Access Compliance Report

Public Rights-of-Way

Intersection ID: 20567	Main Street: PARK_SOUTH_DR	Cross Street: PINE_VALLEY_RD	Location: SE
ADA ID: F86B65F156DF	Ramp Type: PerpDiag	Initial Pass/Fail: Fail	Overall Compliance: No
			Severity Score: 21.25

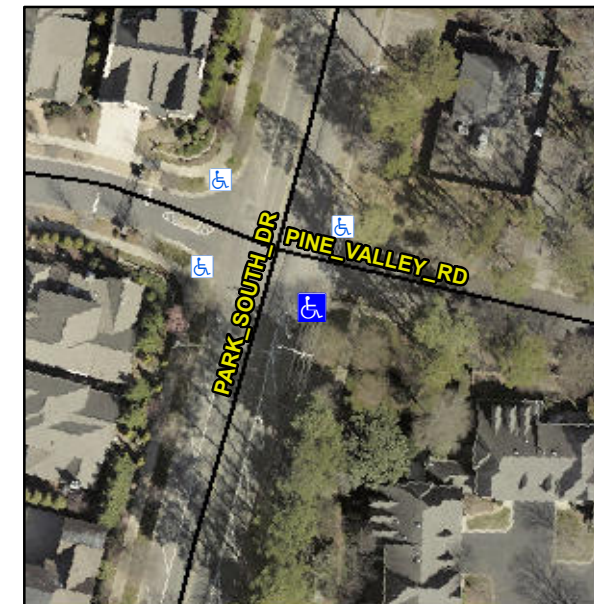
Not Found, R304.5.1, R304.5.3

Compliance	Description	Data	Compliance	Description	Data
N/A	Ramp Length (in)	84.0	Yes	Ramp Slope (%)	7.6
No	Ramp Width (in)	40.0	No	Ramp XSlope (%)	5.9
N/A	Flare Type LT	N/A	N/A	Flare Type RT	N/A
N/A	Flare Slope LT (%)	N/A	N/A	Flare Slope RT (%)	N/A
N/A	Flare Traversable LT?	N/A	N/A	Flare Traversable RT?	N/A
N/A	Landing Length (in)	N/A	N/A	DWS Provided?	N/A
N/A	Landing Width (in)	N/A	N/A	DWS Contrast?	N/A
N/A	Landing Slope (%)	N/A	N/A	DWS Length (in)	N/A
N/A	Landing X Slope (%)	N/A	N/A	DWS Full Width?	N/A
N/A	Landing Curb? (Y/N)	N/A	N/A	DWS Offset (in)	N/A
N/A	Shared Landing?	N/A			
N/A	Gutter Ponding?	Yes	N/A	Gutter Slope (%)	N/A
N/A	Gutter Lip Ht (in)	0.5	N/A	Gutter X Slope (%)	N/A
N/A	Painted X Walk1?	No	N/A	Painted X Walk2?	No
	X Walk 1 Direction	To NE		X Walk 2 Direction	To NW
N/A	X Walk 1 Width (in)	N/A	N/A	X Walk 2 Width (in)	N/A
	X Walk 1 Slope (%)	1.8		X Walk 2 Slope (%)	2.2
	X Walk 1 X Slope (%)	1.4		X Walk 2 X Slope (%)	0.9

Remove & Replace Curb Ramp With Two New Directional Ramps or Equivalent.
